**AMENDMENTS TO THE DRAWINGS**

**REMARKS**

**Fig. 1A**

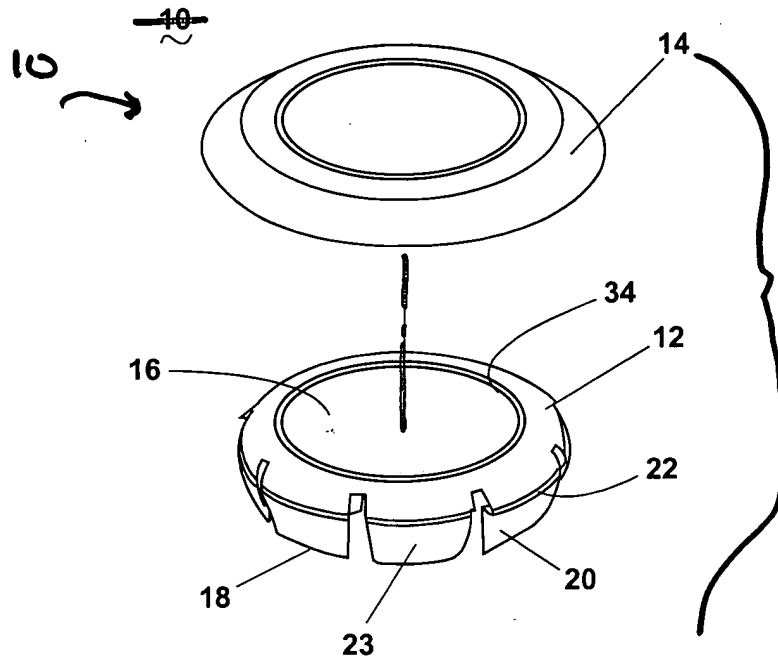
In the Office Action (pages 3-6), the Examiner objected to Figures 1A, 1B, 2, 3B, 4B, 5A, 5B, 6, 7, and 8 for various informalities including a failure to show every feature of the invention as specified in the claims. In addition, the Examiner rejected claims 1-4 and 10 under 35 U.S.C. §112, second paragraph, as being indefinite for failing to particularly point out and distinctly claim the subject matter which applicant regards as the invention. The objections and rejections appear to be inter-related to the extent that they stem from the absence of a panel member in the drawings. In response, Applicants have amended the above-referenced Figures to address each of the informalities cited by the Examiner including amending Figure 8 to show the panel member and its relation to the physical barrier of claims 1-4 and 10. In light of the foregoing amendments, Applicants believe the objections and rejections to be moot and respectfully request withdrawal of the same.

The Examiner further objected to paragraphs [0019] – [0021] for an alleged informality in referencing the Figures. Specifically, the objection to paragraph [0019], being taken here as exemplary, states that “Paragraph [0019] is incorrect because only the plastic carrier (12) of Fig. 1A is shown in Fig. 6, not the entire physical barrier of Fig. 1B ...” (Office Action, page 6). Applicants disagree.

Applicants have amended Figures 1A, 1B, 2, 3B, 4B, 5A, 5B, 6, 7, and 8 to correct inadvertent formatting errors and to address the Examiner's objections. No new matter has been added. In addition, drawing headings have been added to each drawing sheet. Therefore, Applicants are submitting replacement sheets for all six drawings sheets.

At the outset, Figure 1A illustrates an exploded view of physical barrier 12 including a patch 14 and a carrier 12. Figure 1B illustrates an assembled view of the physical barrier of Figure 1A. Paragraph [0019] as originally drafted in the specification states that, “FIG. 6 shows a cross-sectional view of the physical barrier of FIG. 1B according to another embodiment of the present invention.” The Examiner contends that this description is incorrect because Figure 6 only shows the plastic carrier (12) of Figure 1A. Applicants respectfully submit that the Examiner has misconstrued what is shown by Figure 6. Applicants draw the Examiner’s attention to Figure 6 and note that, consistent with the original language of paragraph [0019], Figure 6 clearly shows a cross-sectional view of the entire physical barrier including the patch 14 and the carrier 12. As previously stated, the argument as set forth above with respect to paragraph [0019] was exemplary, and is therefore equally applicable to paragraphs [0020] and [0021]. Accordingly, the objections with respect to paragraphs [0019] – [0021] should be withdrawn.
